Snapshot of progress in the development of the EU UNECE WLTP.

**Administrative Working Group (AdminWG) addressing the Implementation of the
WLTP in EU Legislation**

This document is a draft of the transposition of the WLTP GTR (Phase 1a) into EU and UN/ECE regulation.

In its current format the document is being prepared as if it will become a new annex (Annex XXI) to EU Regulation No 692/2008. Therefore the annexes in the GTR have been renamed as 'sub-annexes' for Annex_XXI (this document).

Figure A1/14
Downscaled extra high speed phase of the Class 2 WLTC

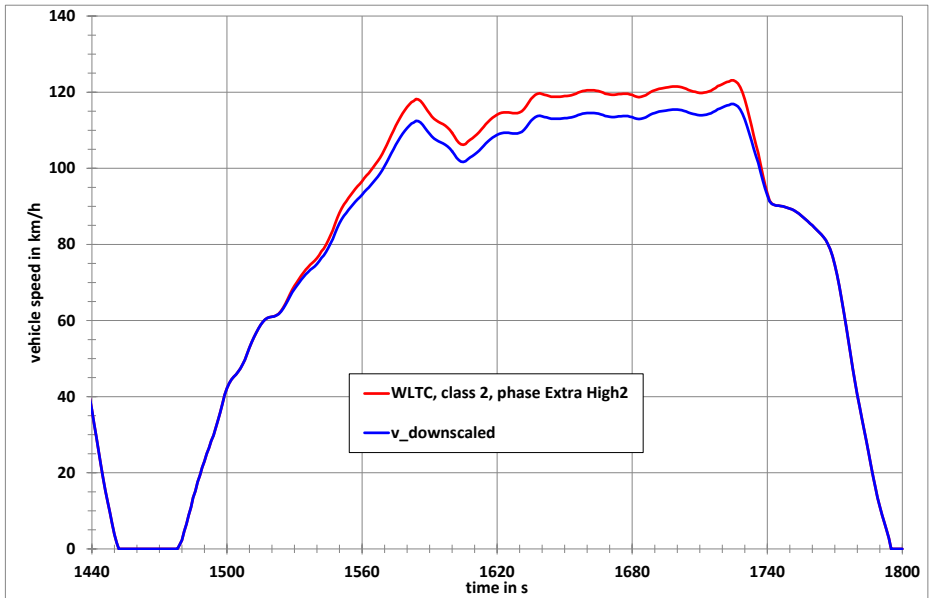
- Deleted:
- Deleted:
- Comment [RCG38]: Equation number update in 20.05.14 GTR
- Deleted:
- Deleted: 3
- Deleted:
- Deleted:
- Deleted: 4
- Deleted: With
- Deleted: class 2
- Deleted: c
- Deleted:
- Deleted: c
- Deleted:
- Deleted: c
- Deleted:

Figure A6/1
 Flowchart for the number of Type 1 tests

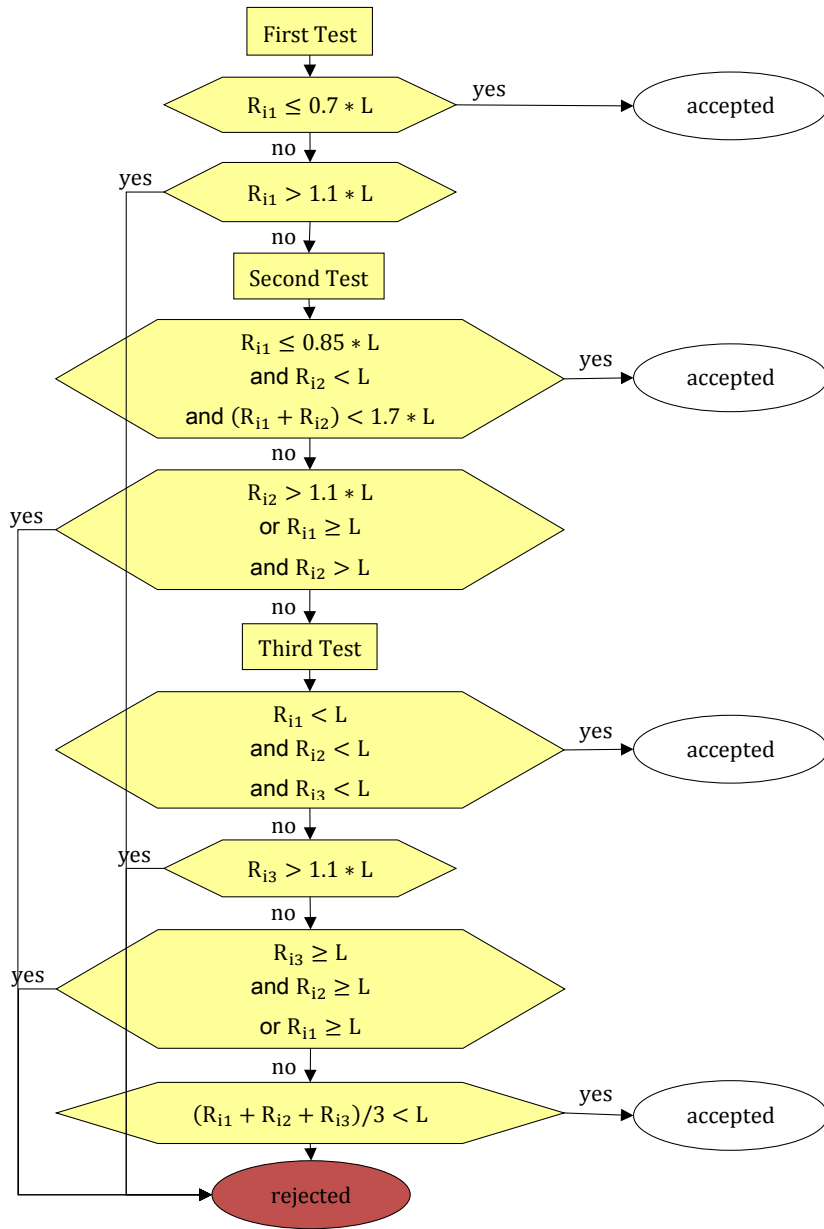
Comment [RCG117]: AdminWG 040414 – replace “regional” with “emissions”.

Comment [RCG118]: Updated in 230414 GTR benchmark to change "*" to "x"
 Deleted:
